PORTION OF SE QUARTER OF SEC 27, TWN 20 N, RGE. 4 E, W.M.
CITY OF PUYALLUP, PIERCE COUNTY, WASHINGTON

COVER SHEET
CIVIL PLANS

Title: COVER SHEET
CIVIL PLANS
FORTRESS - PUYALLUP

Title: **SITE PLAN**

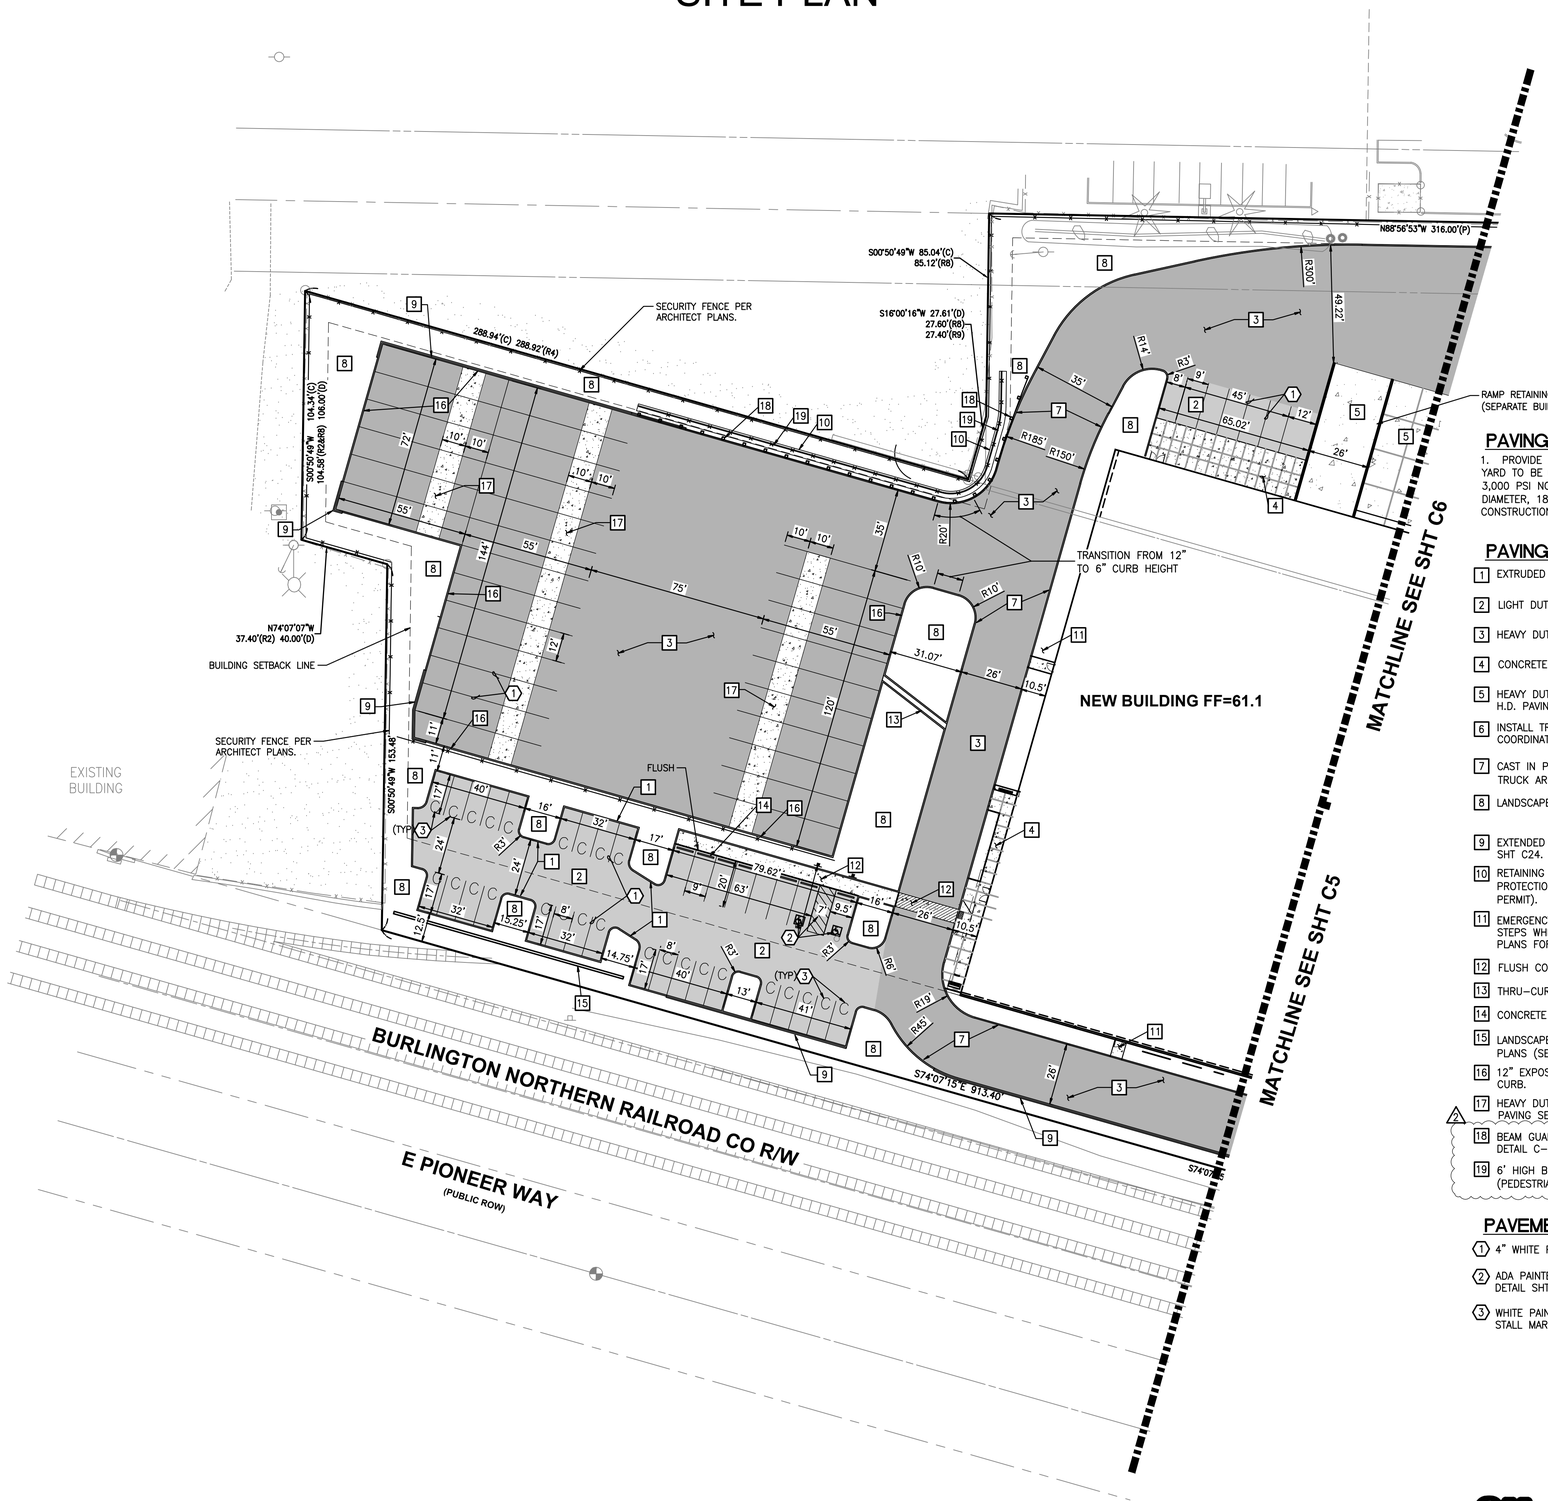
What set of Geotech plans is this referring to? [civils, pg 4]

Title: **SITE PLAN**

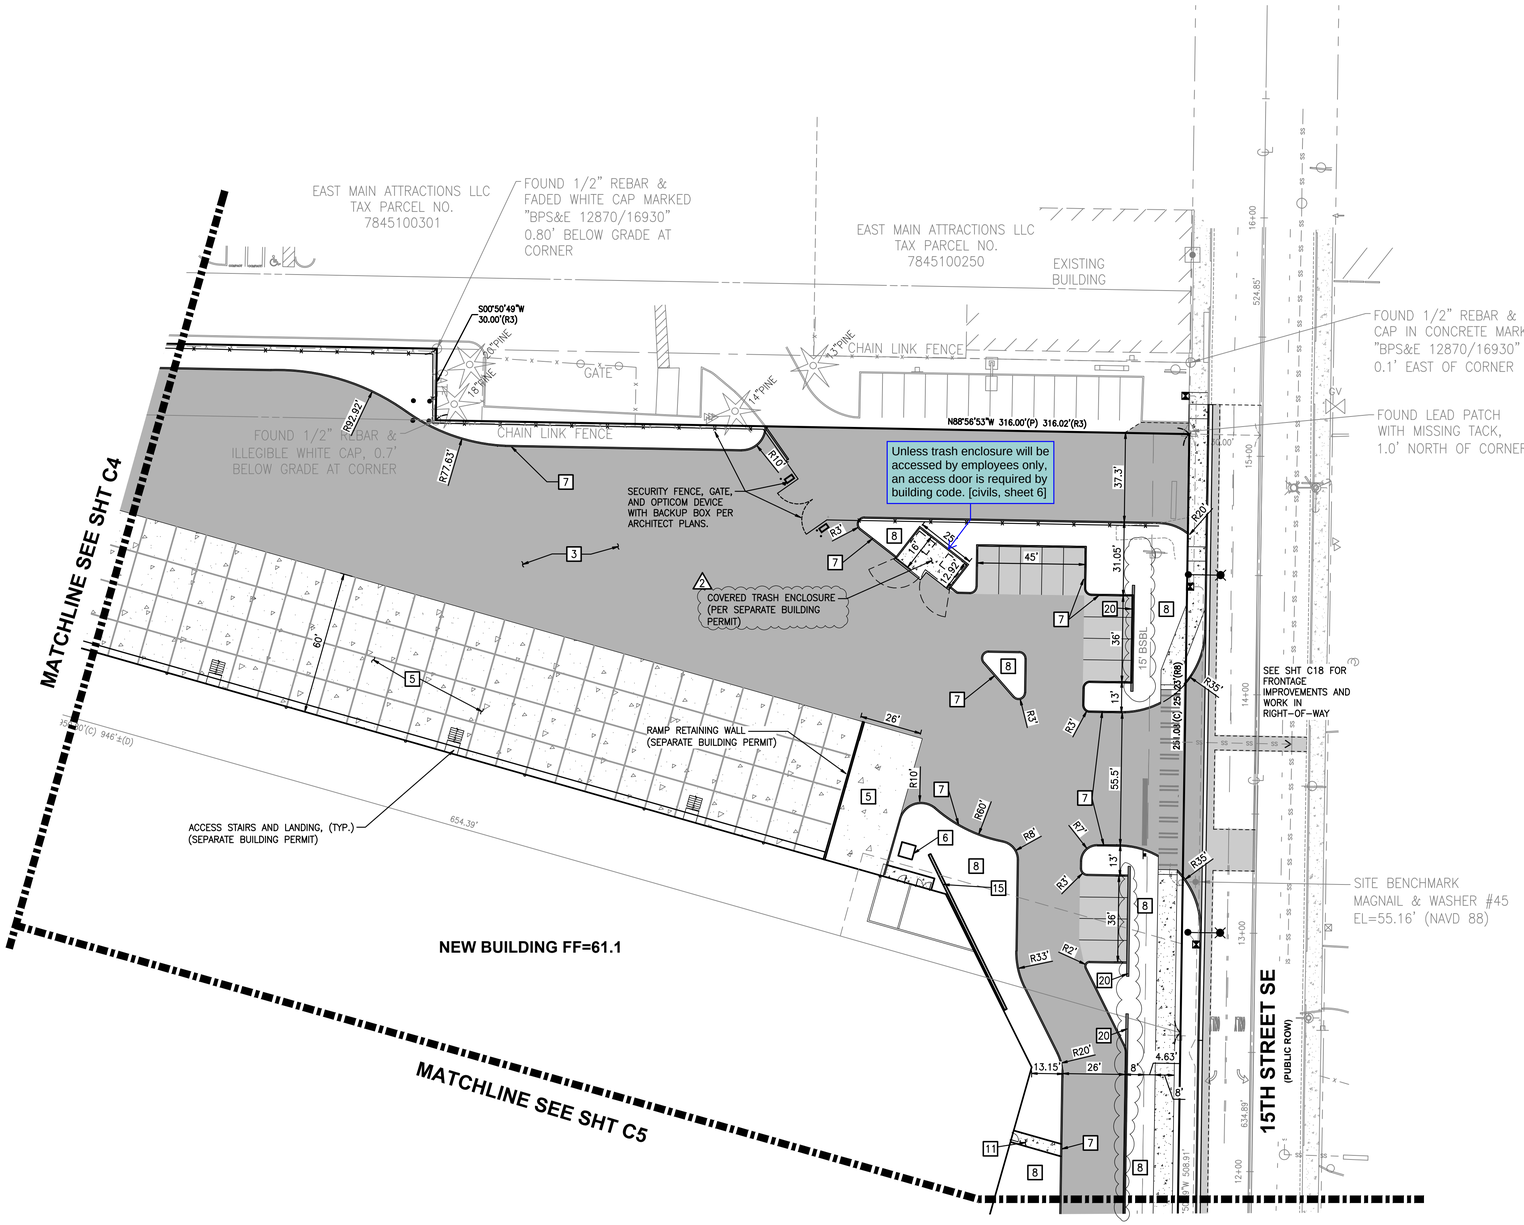
Reference the wall detail/page. [civils, pg 6]

Reference the wall detail and page. [civils, sheet 6]

Title: GRADING AND DRAINAGE PLAN

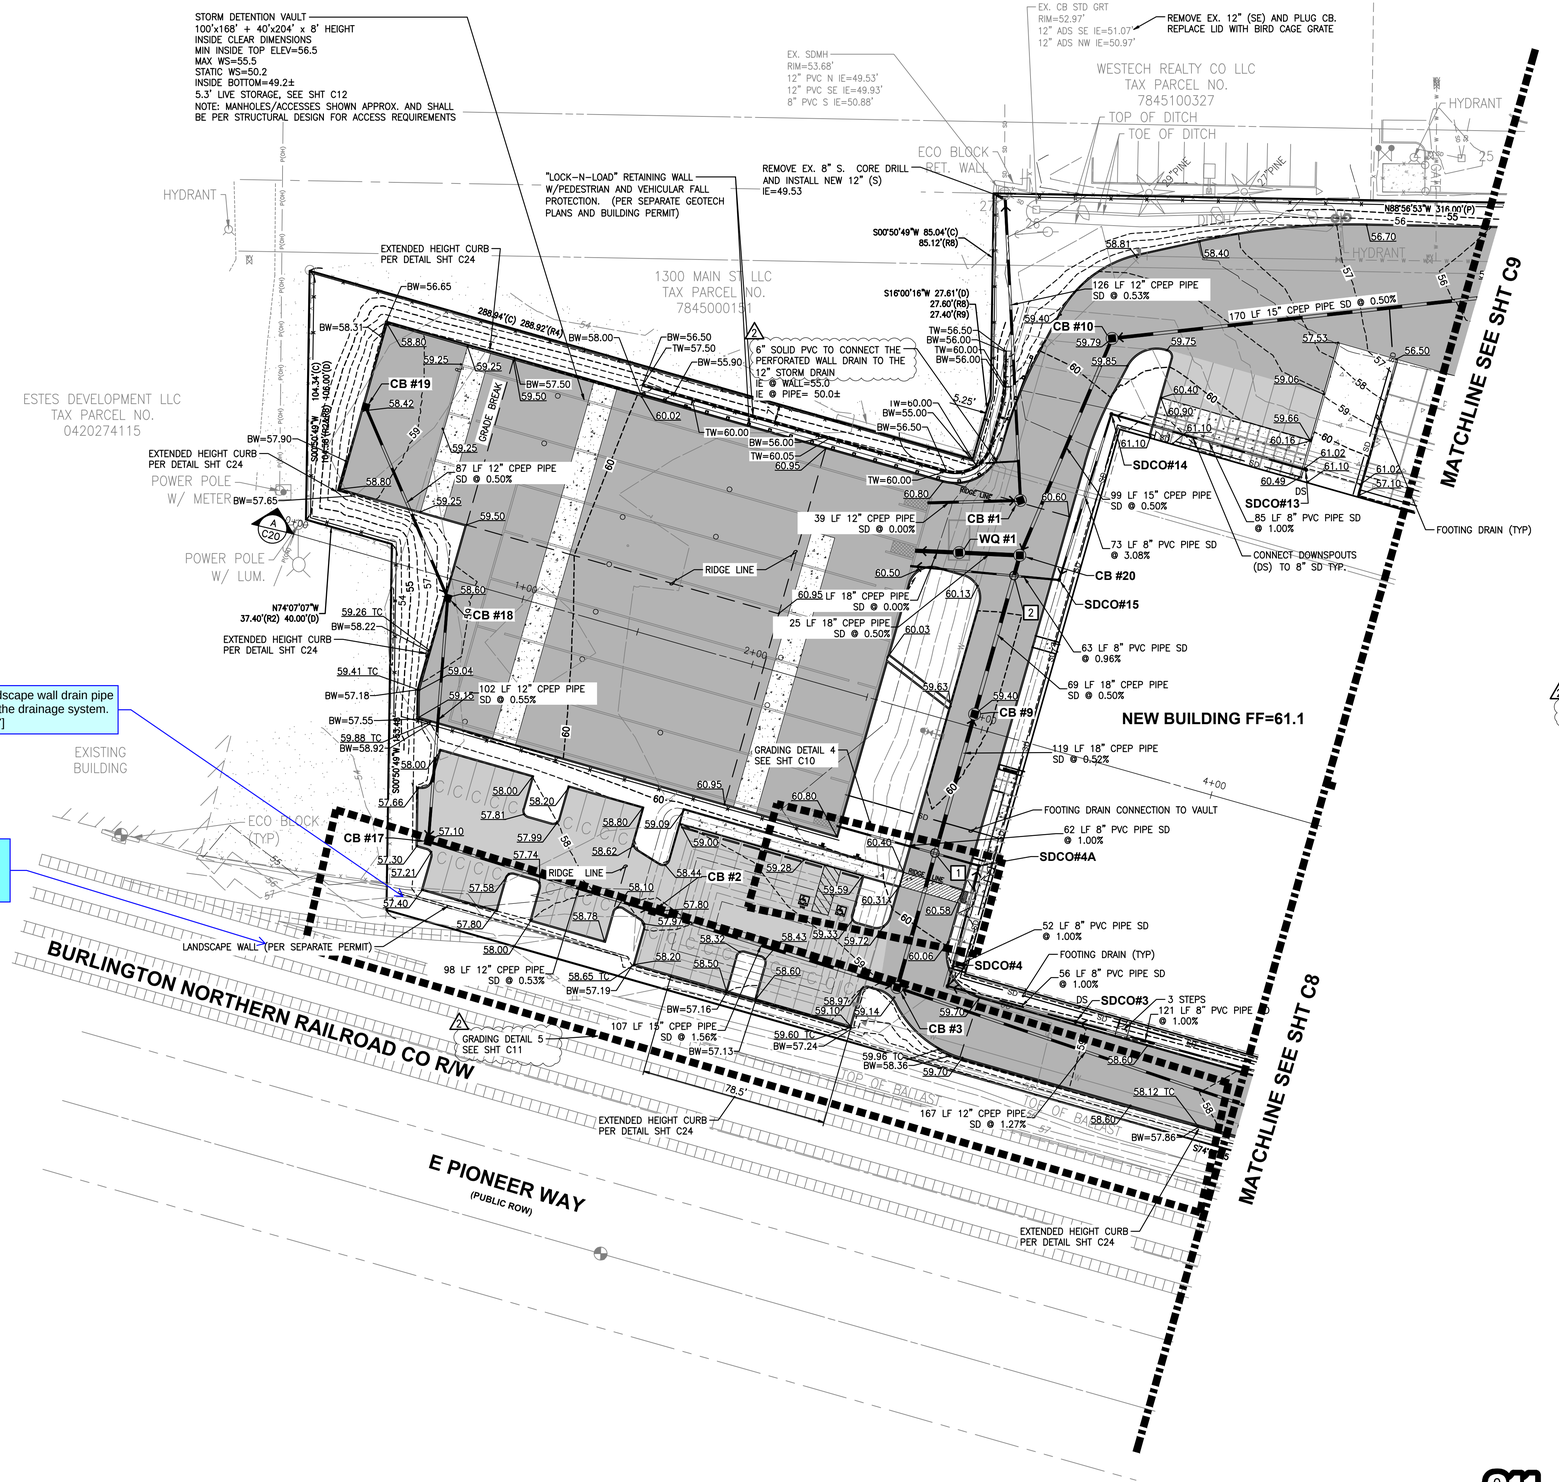
Show the landscape wall drain pipe connected to the drainage system. [civils, sheet 7]

Reference the landscape plans as well, 5/L5.10. [civils, sheet 7]

GRADING DETAIL 5

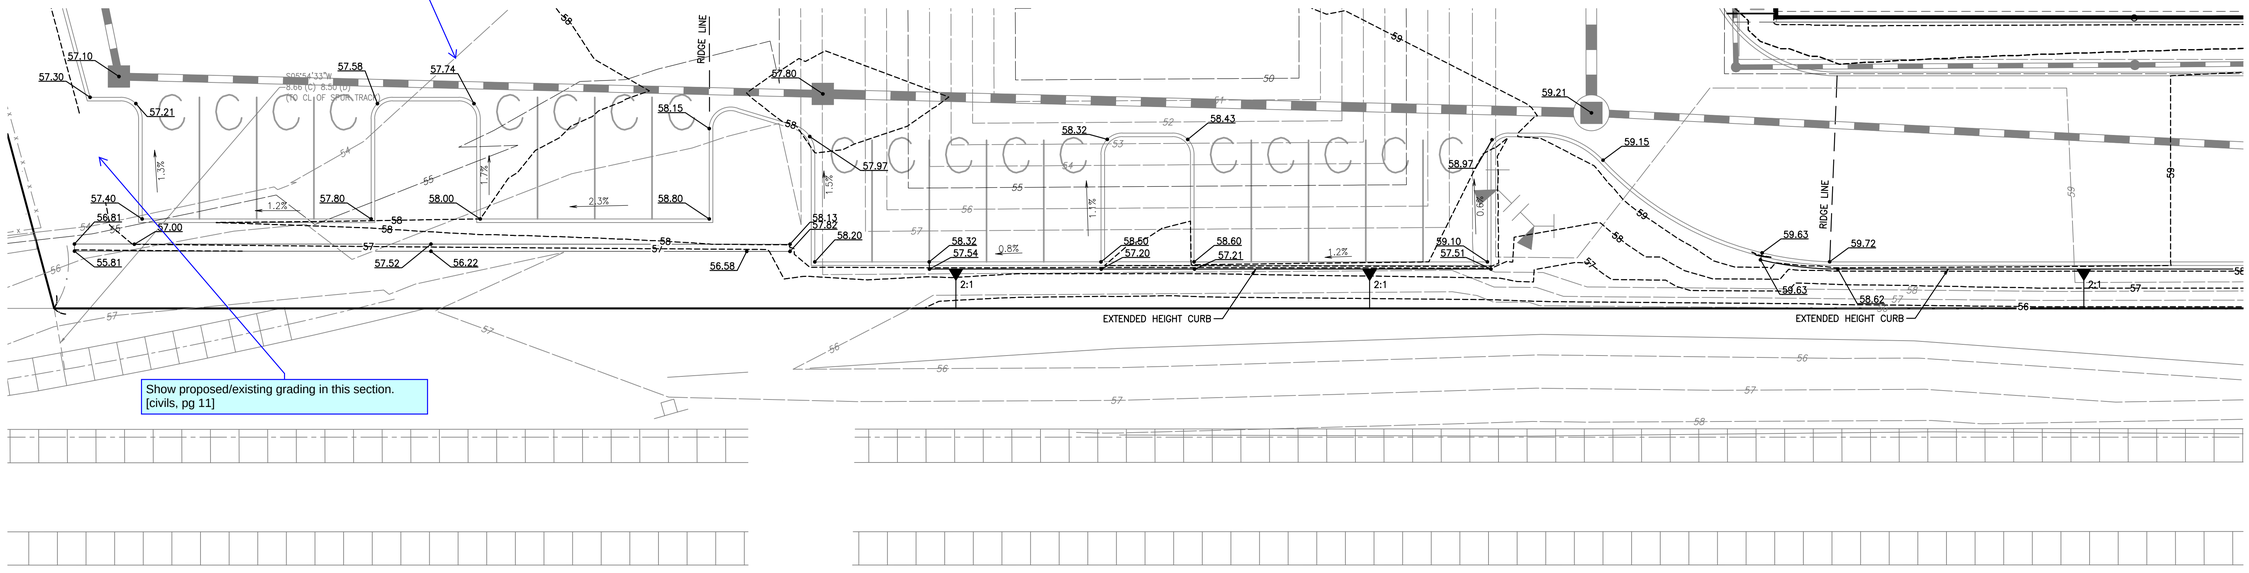
What is this contour linetype representing. This does not match the existing or proposed contour linetype within the legend on sheet C2. [civils, sheet C11]

Show proposed/existing grading in this section. [civils, pg 11]

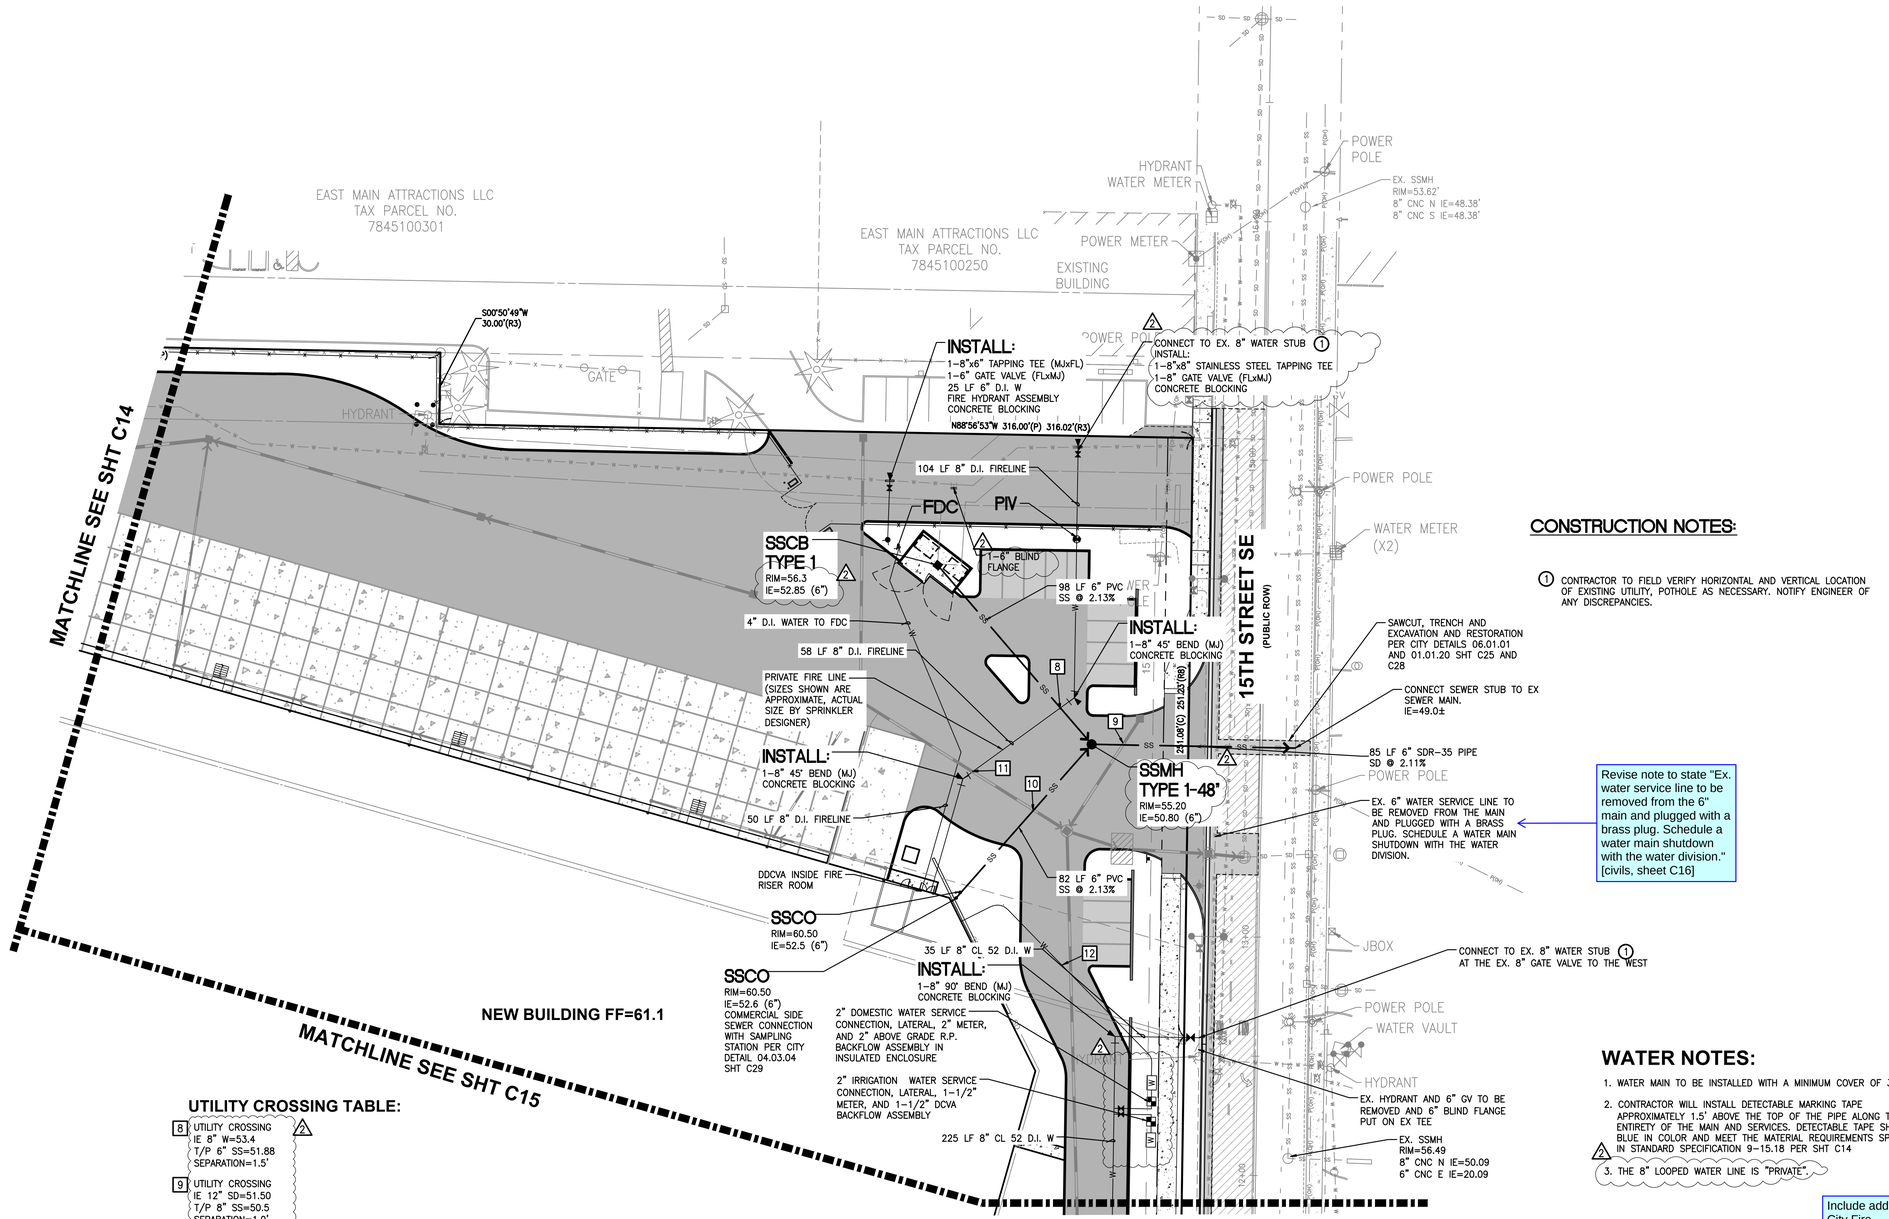
Revise note to state "Ex. water service line to be removed from the 6" main and plugged with a brass plug. Schedule a water main shutdown with the water division." [civils, sheet C16]

Include additional City Fire Hydrant/FDC approval block. [civils, sheet C16]

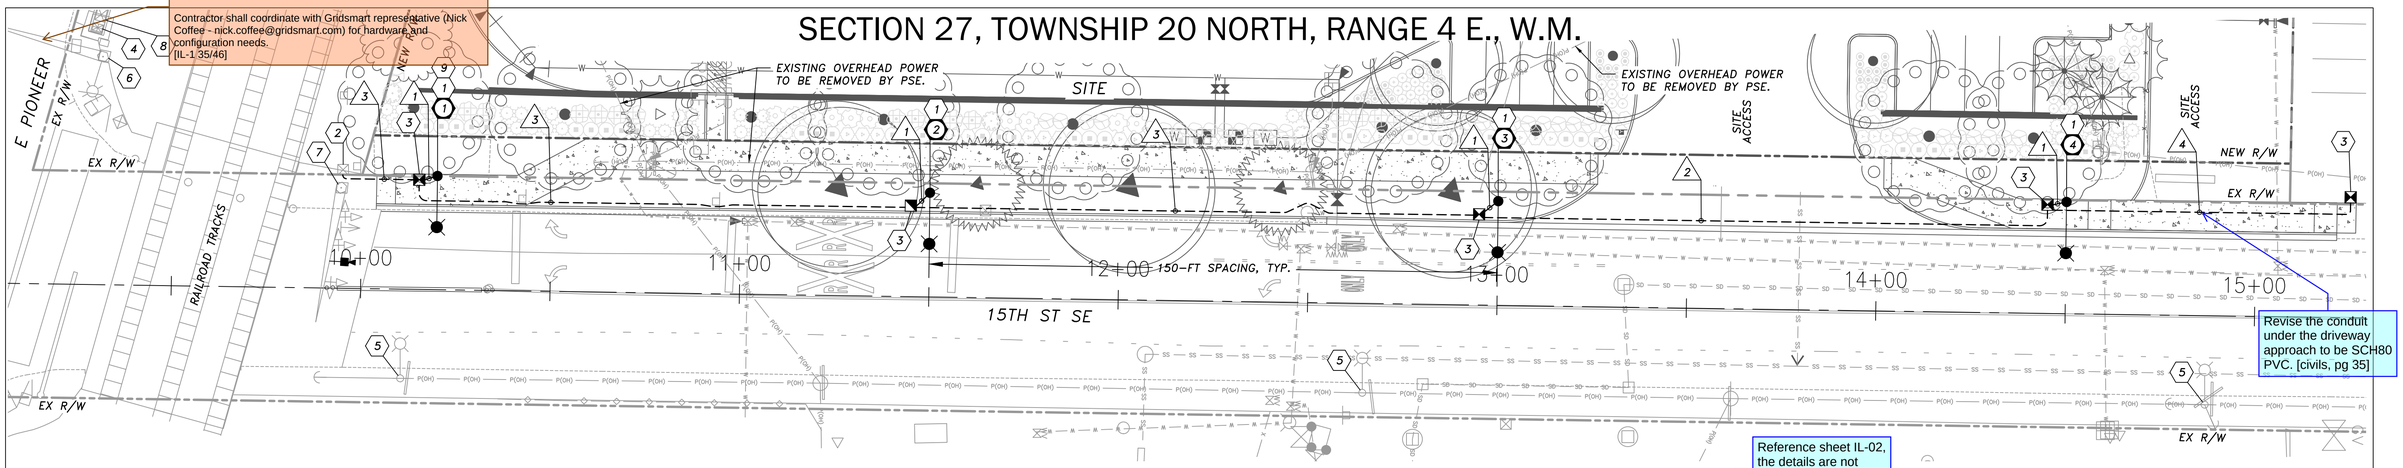
Revise the conduit under the driveway approach to be SCH80 PVC. [civils, pg 35]

Reference sheet IL-02, the details are not shown on this sheet. [civils, pg 35]
